SERVICE INSTRUCTION

SI_SPLS_001
Revision 01

HOT KIT INSTALLATION PROCEDURE

Summer's higher ambient temperature can cause oil and coolant temperatures to run uncomfortably close to redline. This Service Instruction introduces a Hot Kit Installation Procedure.

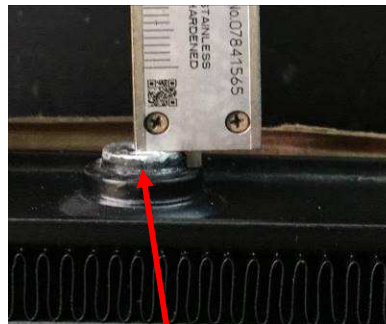
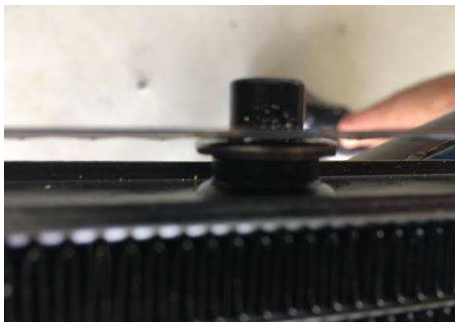
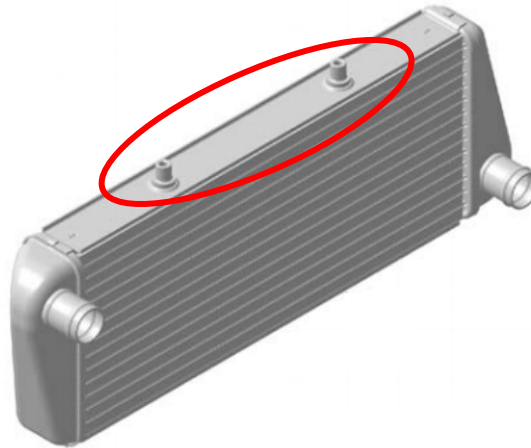
1. Remove engine upper and lower cowlings.
2. Remove the fireproof fabric from the lower engine cowling.
3. Using a sanding machine wear out bafflers and oil cooler supports from both sides of the lower cowling.
4. The engine cowling itself shall not be sand or damaged however, it is necessary to removed bafflers and supports completely in order to fit the new ones.
5. Set the supports at **(5' 3/4" or 145 mm)** from the rear part of the cowling according to the picture below.

6. Mark the correct position of the bafflers and oil radiators supports according to the picture below.

7. Apply epoxy resin loaded with micro balloon on the whole contact surface to glue the new bafflers and supports (Items 9 / 10) on the lower engine cowling according to the picture bellow.
8. Finish and paint as necessary.
9. Reinstall the fireproof fabric or similar (Item 11).

Height = 1/12" or 2 mm

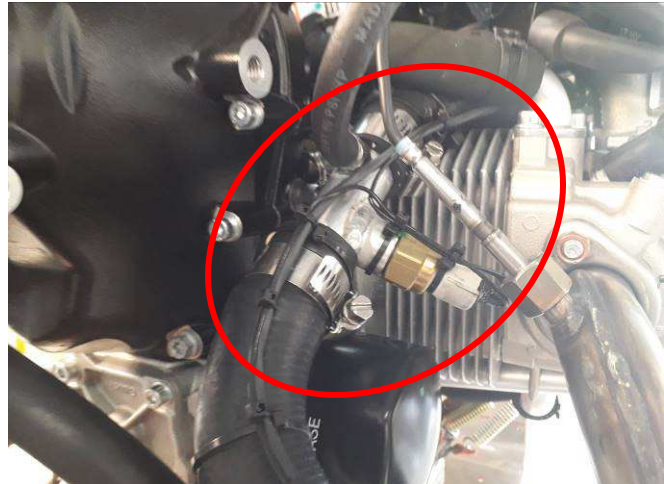
1. Disconnect the left pipe from the radiator and drain coolant from the system.
2. Remove the radiator.
3. Rework all four supports as shown at the picture below (these should have height of **1/12" 2 mm**).

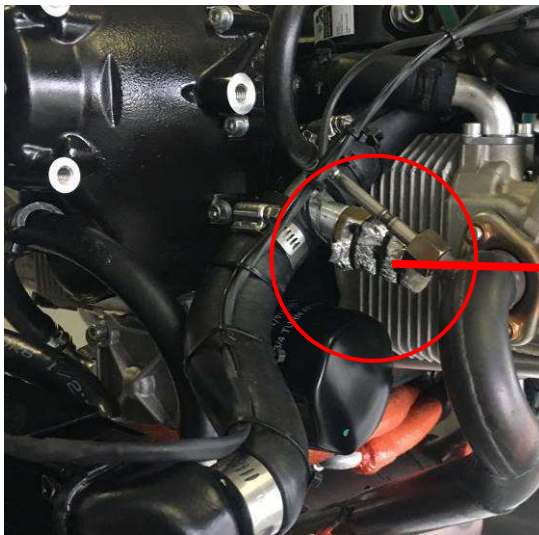
5. Install the supplement with sensor (Item 8) in the cooling system line. Cutting off about **(1 inch or 25mm)** of the original pipe connected between the radiator and the new supplement is required considering the new supplement is **1 inch or 25 mm** longer than the original.

6. Isolate the sensor using fireproof fabric or similar around the part.
